Re: Consolidated Edison Company  
of New York, Inc.  
AEC Docket No. 50-247

Attachment:  
"Additional Information on  
Emergency Core Cooling Analysis",  
8/16/71

ADDITIONAL INFORMATION ON  
EMERGENCY CORE COOLING ANALYSIS

FIGURE 1

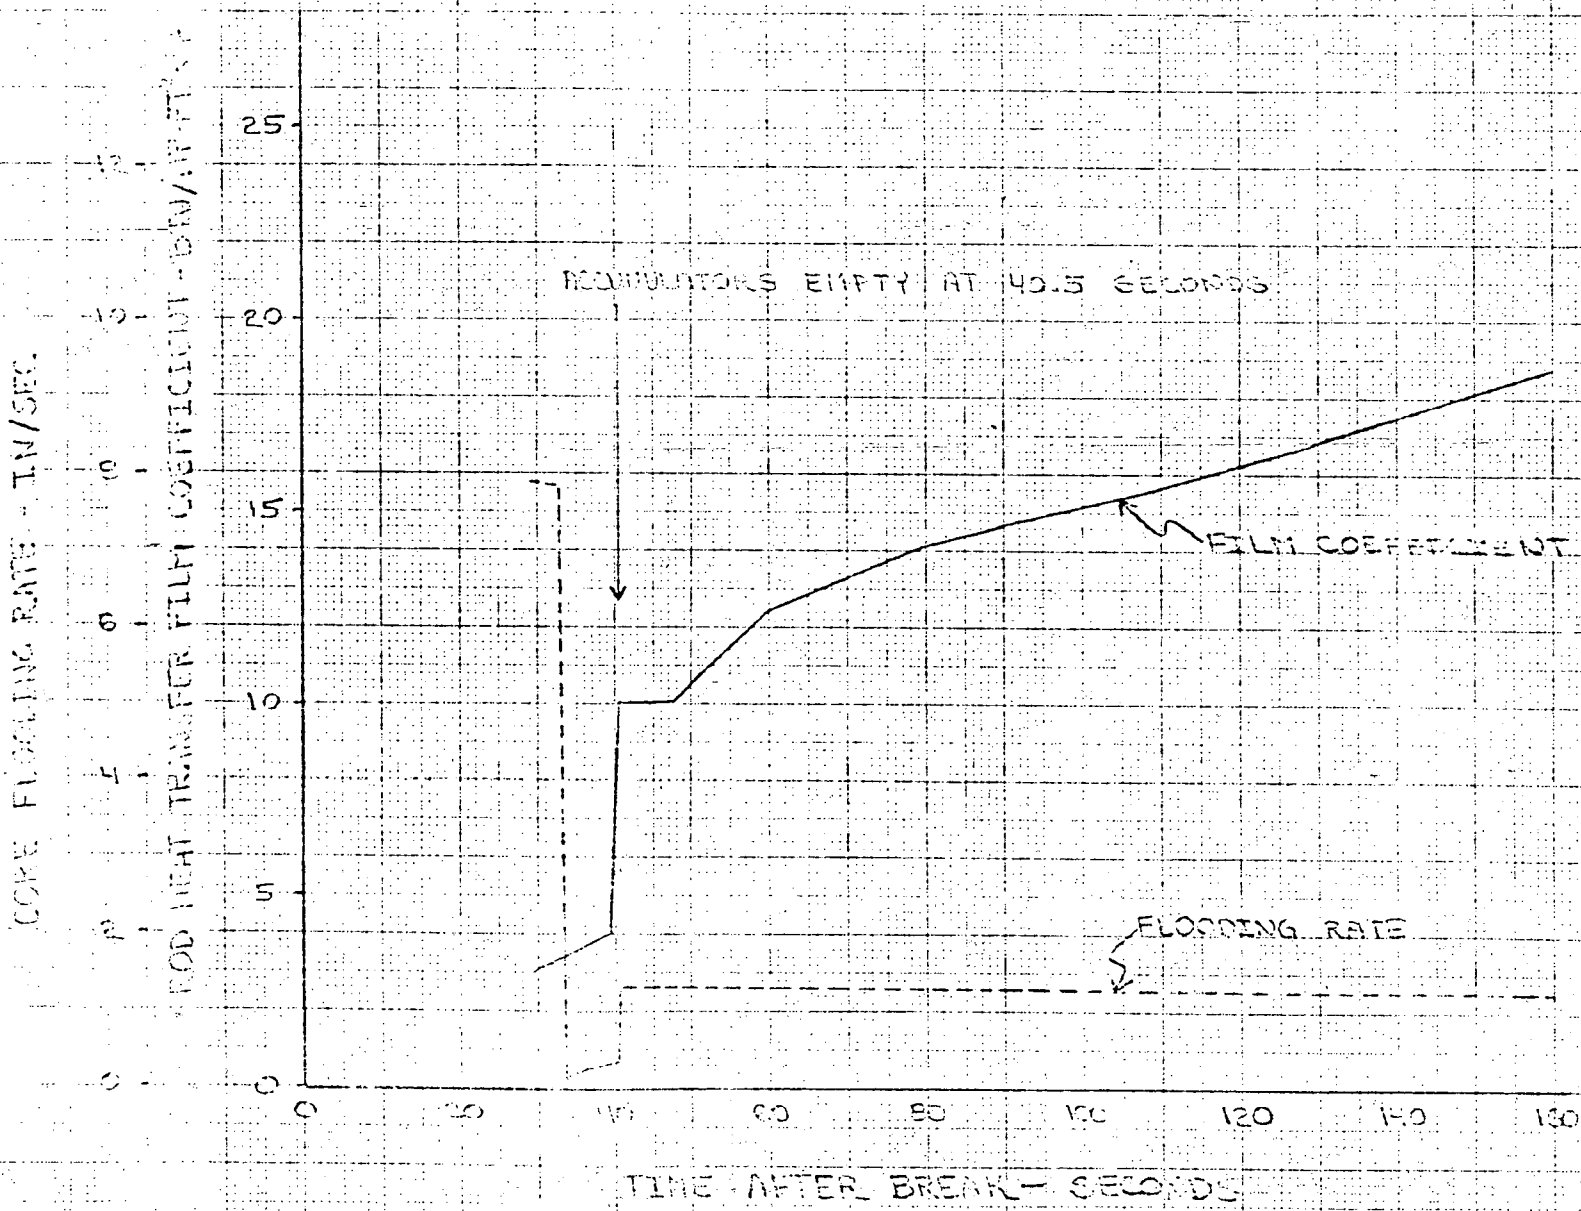
Figure 1 is a plot of both the core flooding rate and the hot spot film heat transfer coefficient as a function of time used in the double-ended cold leg break Loss of Coolant Analysis. The time that the accumulators empty is also indicated on the graph.

FIGURE 2

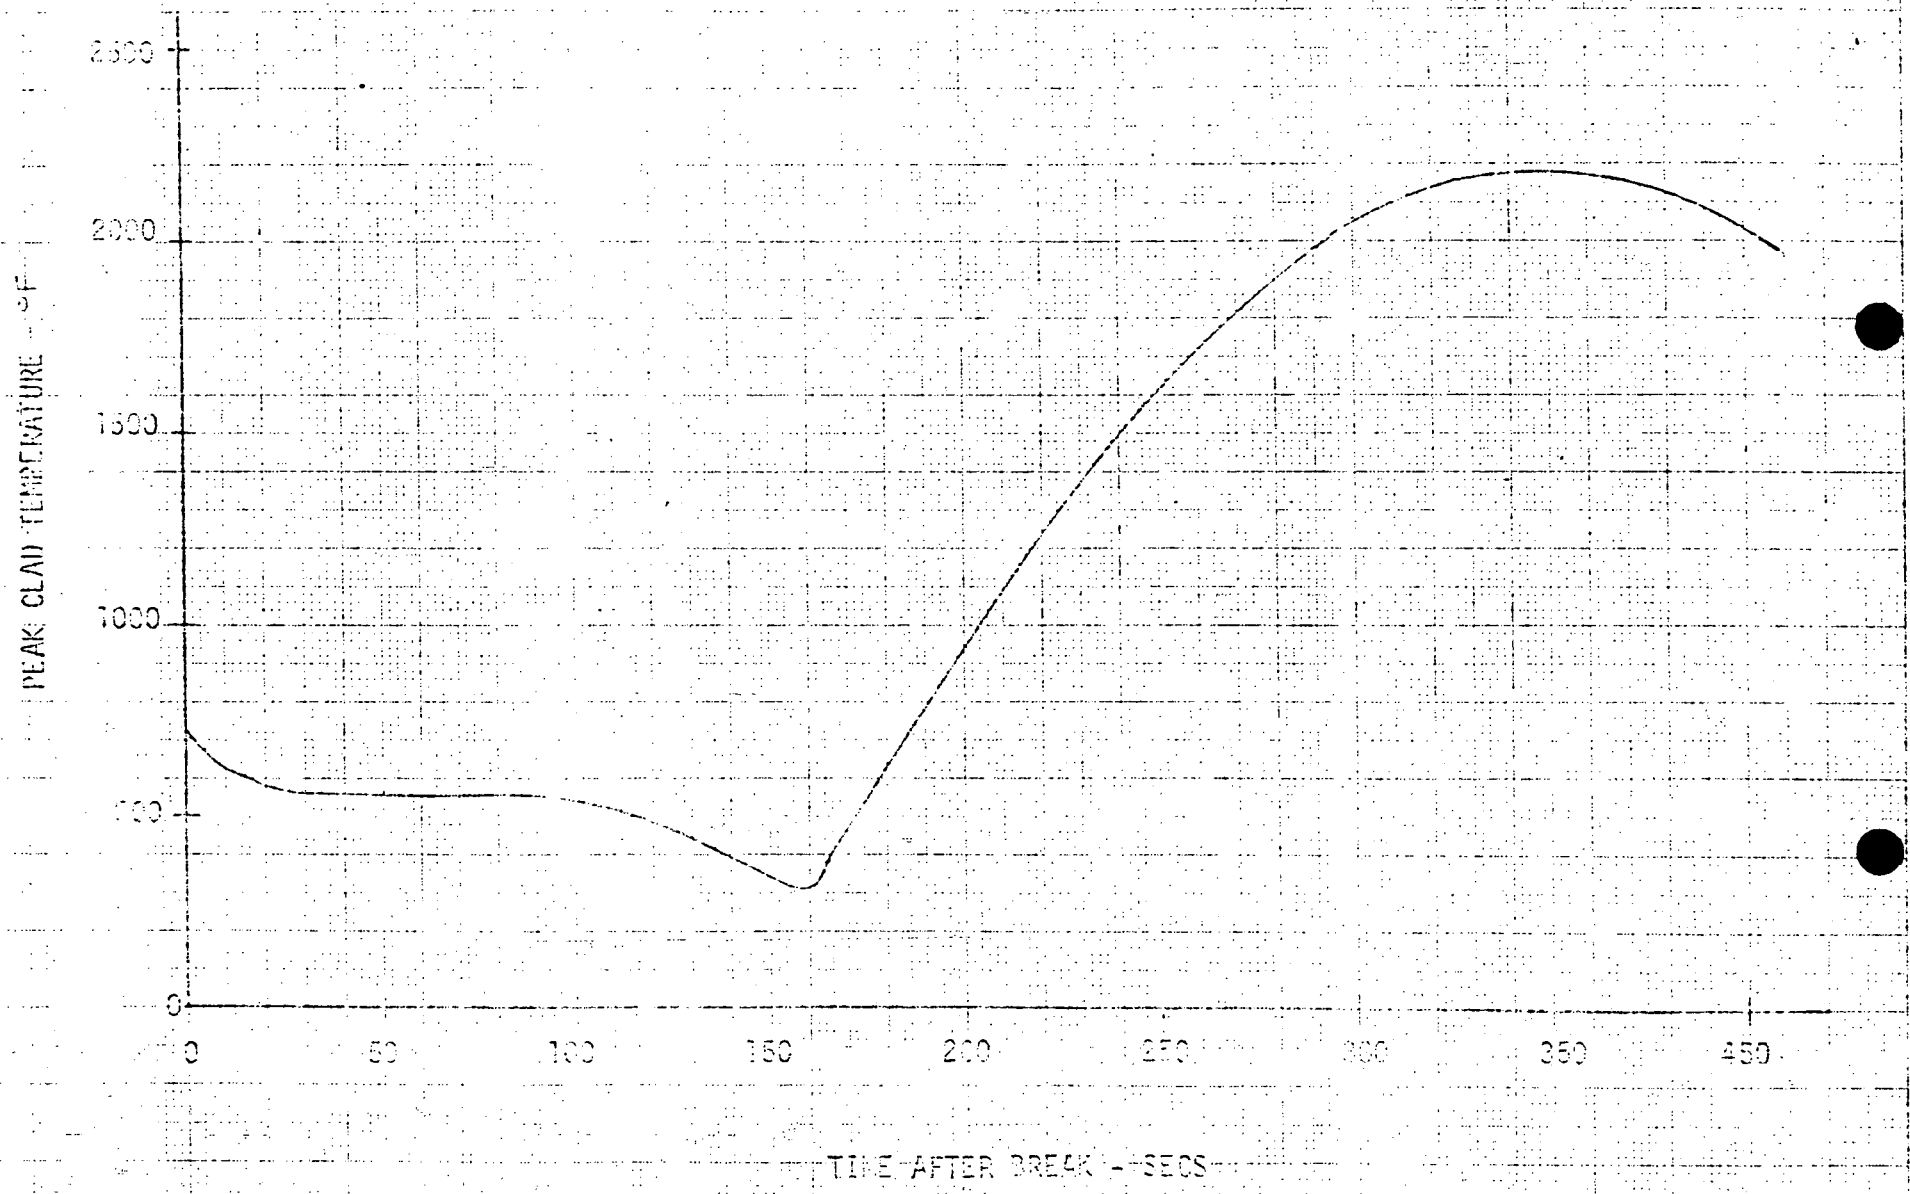
An analysis has been performed for the 0.5 ft<sup>2</sup> cold leg break using the interim criteria. The peak clad temperature was 2185°F. This is greater than the peak clad temperature calculated for the 3.0 ft<sup>2</sup> cold leg break, which is not surprising because a decrease in break size increased the amount of the accumulator water than can be injected before the end of blowdown. In fact, for these smaller breaks the clad temperature rise is stabilized before the end of blowdown, but on the other hand, these smaller breaks define the lower limit of the break size for which accumulator water loss need be considered because of the limit on the maximum amount of water that can be passed through the break and the much lower steam velocities in the system.

Figures 2 through 8 provide details of the 0.5 ft<sup>2</sup> cold leg break transient analysis.

FIGURE 27  
8 DE Breuk

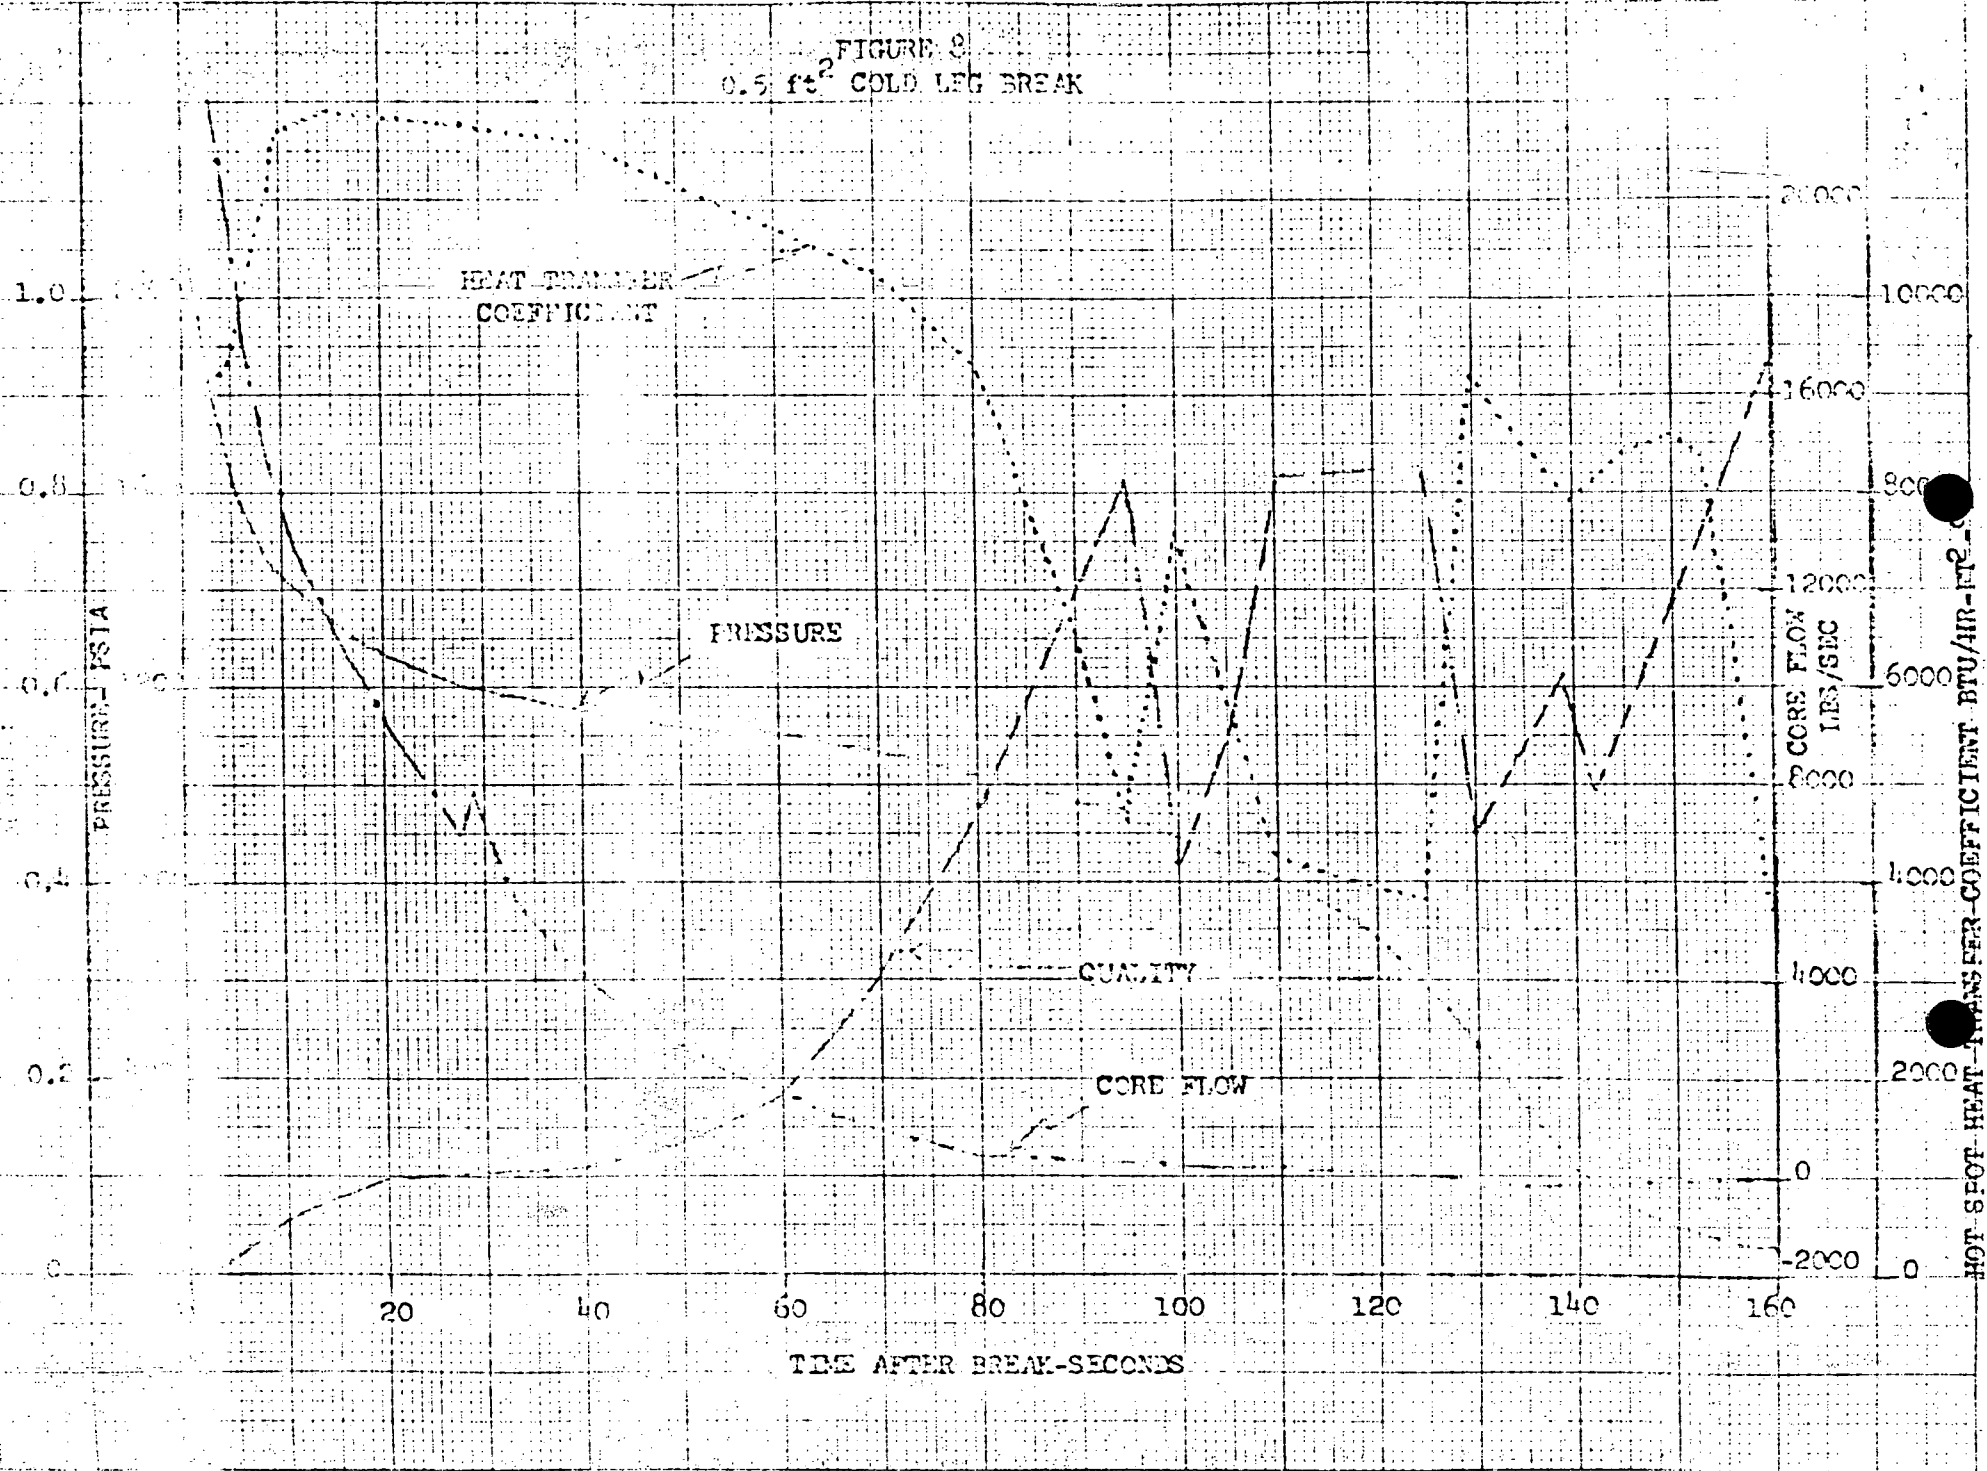
Items 1 and 2 provide additional details on the reflooding analysis and an analysis of the 0.5 square foot cold leg break. Items 3 and 4 provide clarifying information which demonstrates that the analysis in the above-mentioned document is in accordance with Appendix A, Part 3, of the Commission's interim policy statement. There is also included in the attachment a replacement for Figure 27 to correct a typographical error in identifying the broken hot leg curve.
